Service Bulletin

BKSB-1004
Issue Date 09-29-00

Issue: E_H (140 F+).

Affected Models: E_H FLE DE 630000 032999.

F 1 1

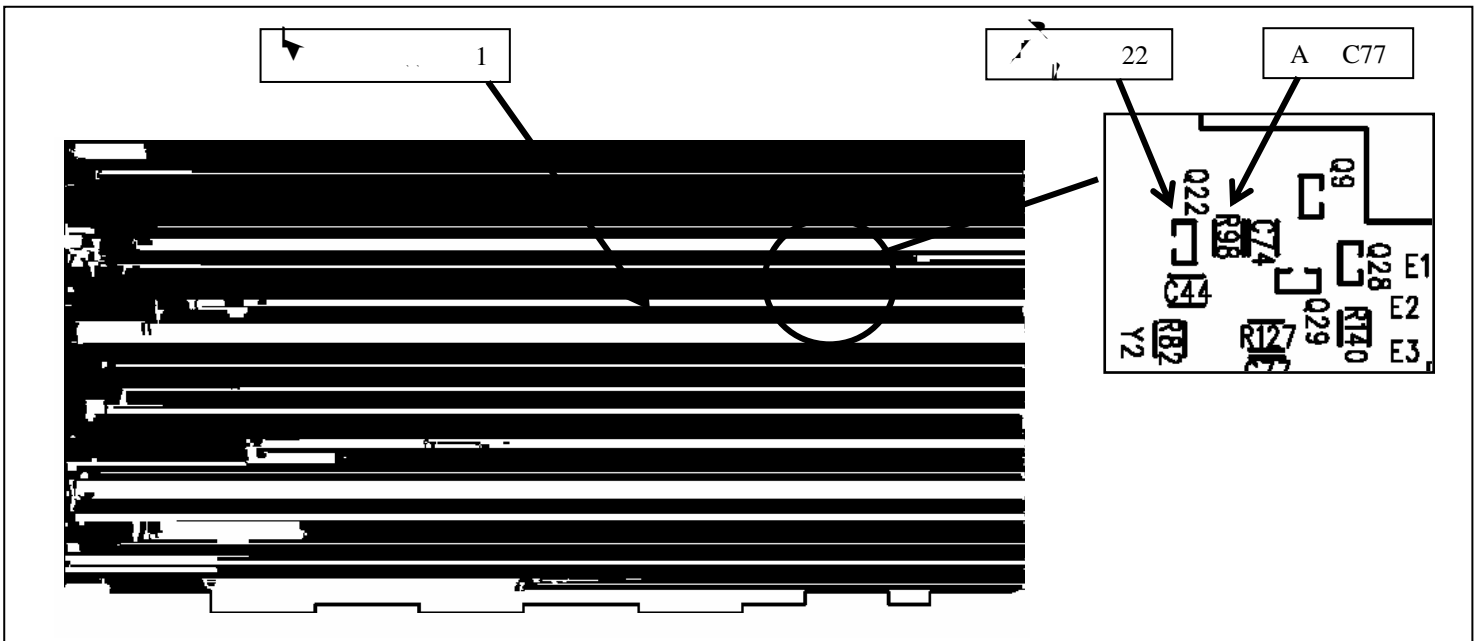
1. i
2. D
) 0- 6.1(48) 1() /F5)-11(; 87.3 D(/0 D) 3(37 0.0007
